BEFORE THE FACT FINDING TASK FORCE
OF THE NUCLEAR REGULATORY COMMISSION

Davis-Besse event :
of June 9, 1985 :

Proceedings before the Nuclear Regulatory
Commission Fact Finding Task Force in regard to the
aforementioned event, held at Conference Room 210,
Davis-Besse Nuclear Plant, Oak Harbor, Ohio,
commencing on Tuesday, June 18, 1985, at 4:26
o'clock p.m.

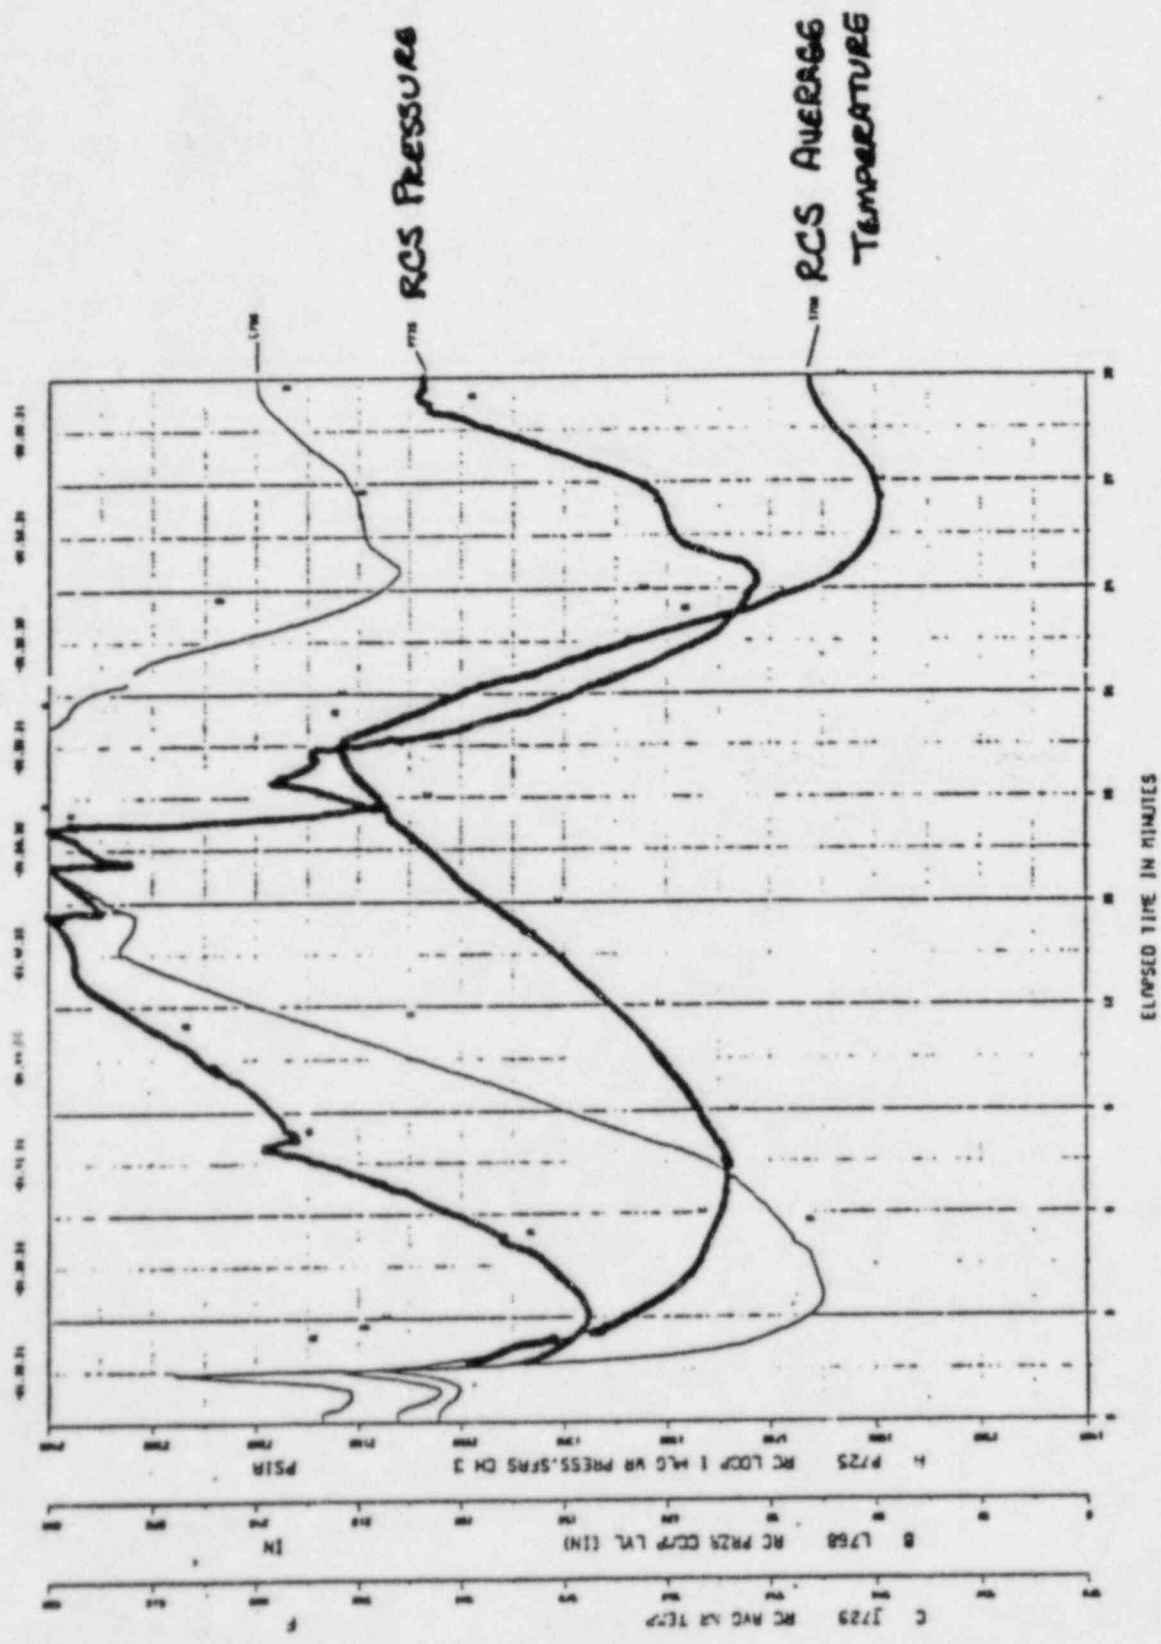
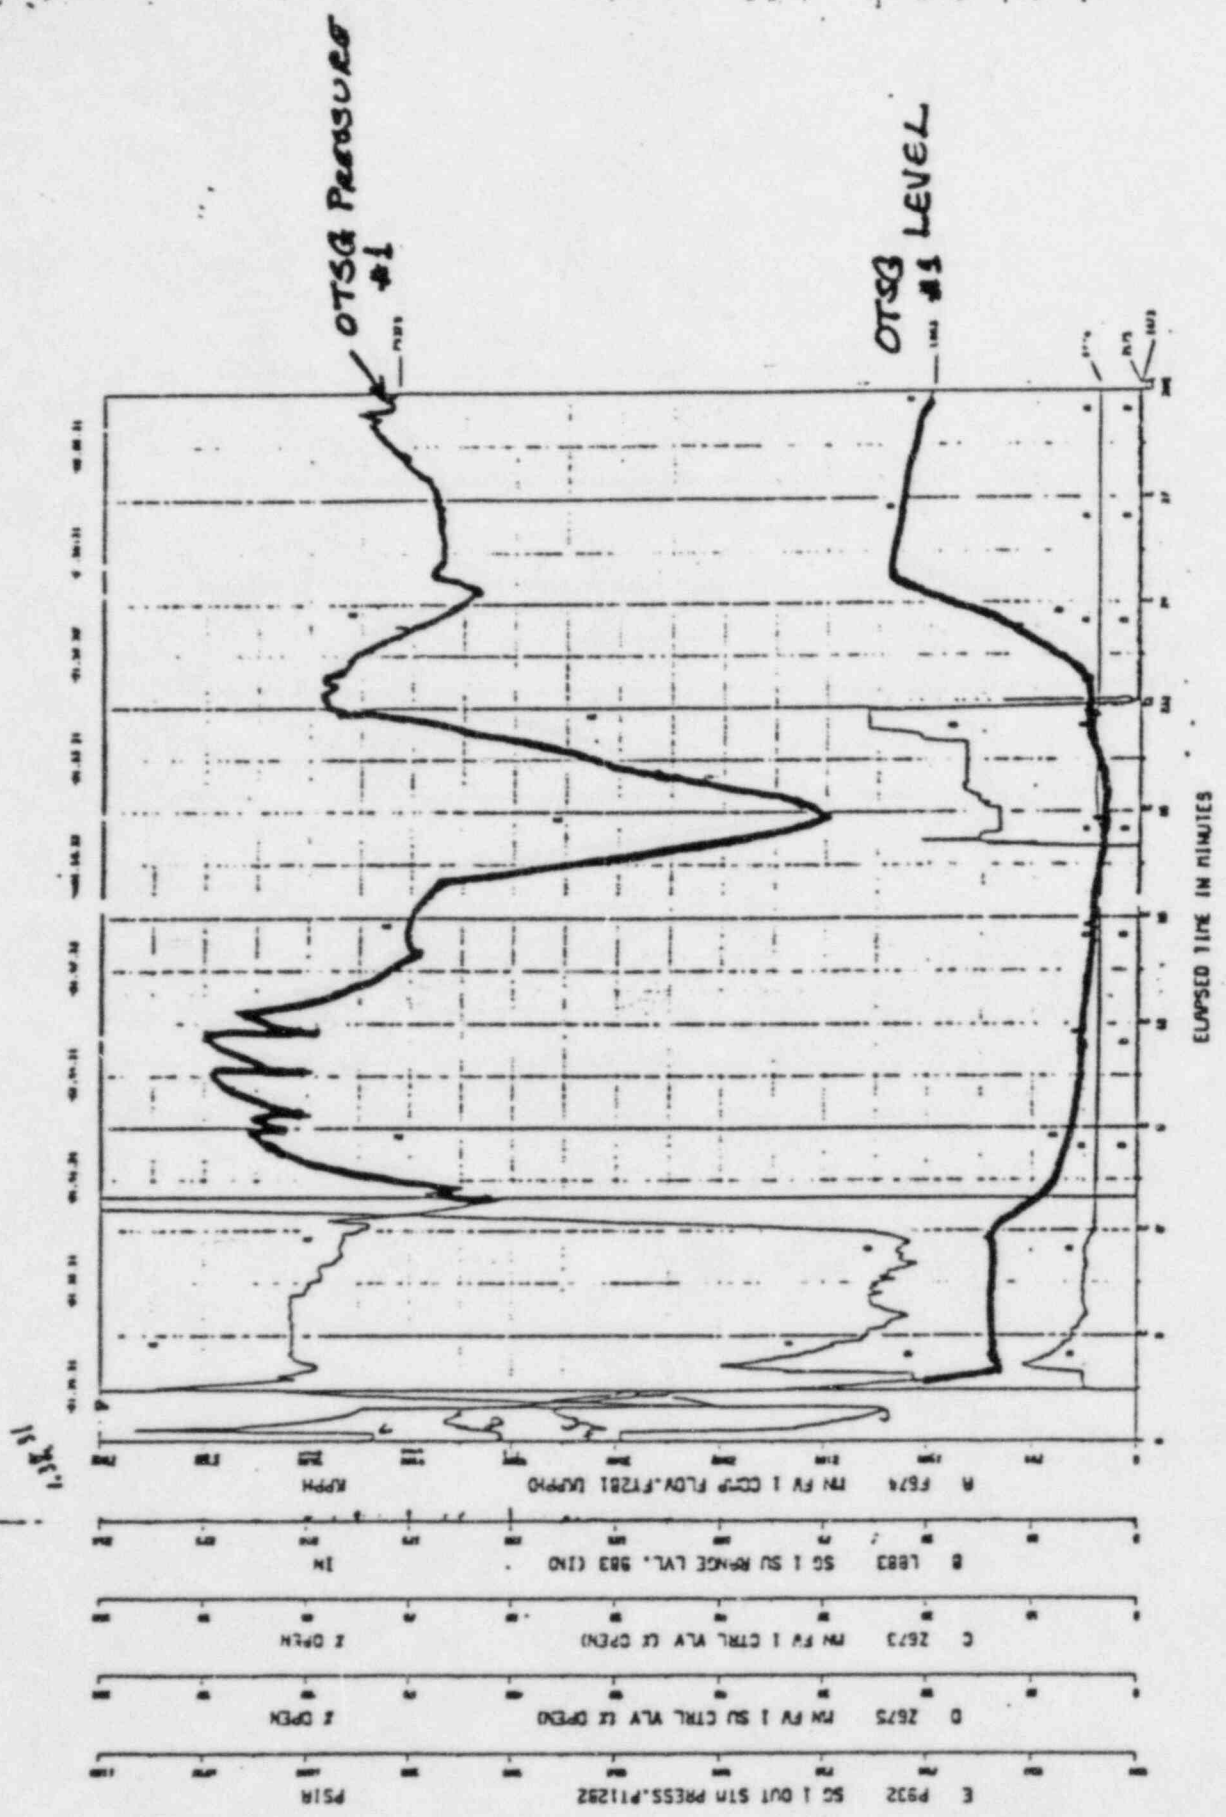
15 MR. BATCH: Page five we had one last
16 comment. In the third paragraph of additional
17 complications there we are talking about the desuper-
18 heating spray for the auxiliary steam system allowed
19 water into the main steam piping.

20 And then it says the water slug damaged
21 one of the main turbine bypass valves. I would like
22 to add the sentence to that part of this. It is
23 believed. We are not sure. We are less positive on
24 that at this point in time.

1 MR. ROSSI: How about if we say when
2 vacuum was restored and the MSIV's opened, the water
3 slug apparently damaged the main turbine bypass
4 valves.

5 MR. ROWLES: Or one of the main turbine
6 bypass valves was damaged.

*The desuperheating spray ~~regulator~~ for the auxiliary steam system ~~had been bypassed prior to the transient. This~~ allowed water into the main steam piping. When vacuum was restored and the MSIVs opened, the water slug damaged one of the main turbine bypass valves.
